# ASSESSMENT OF DAM SAFETY OF COAL COMBUSTION SURFACE IMPOUNDMENTS – DRAFT REPORT

**Prairie Power, Inc.  
Pearl Power Plant  
Pearl, Illinois**

Prepared for  
*United States Environmental  
Protection Agency  
Washington, D.C.*

October, 2012  
Revision 1, January 2014

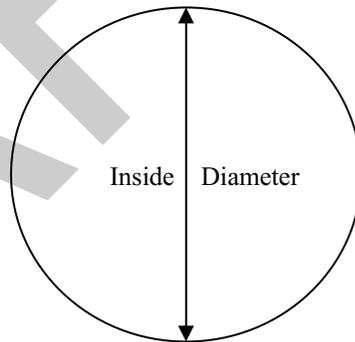
- Vertical portion of outlet pipe broken
